REMARKS

Serial No.: 09/484,292 Art Unit: 3743

For: CONDENSER

ANNOTATED

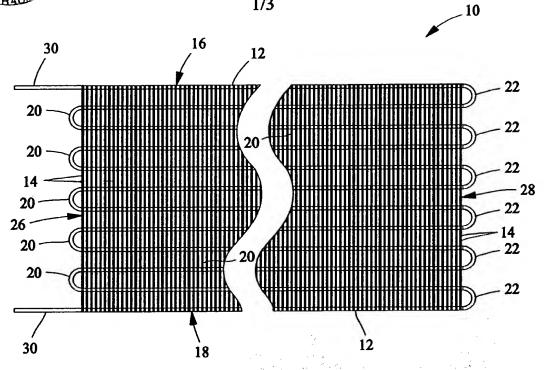
In the drawings, Figure 2 has been amended to include reference number 50 for the substantially circular outer diameter of the refrigerant tube 12 previously shown in Figure 2 and other figures. The amendment adds no new matter.

The specification has been amended for consistency with Figure 2, reciting the substantially circular outer diameter 50 of the refrigerant tube 12.
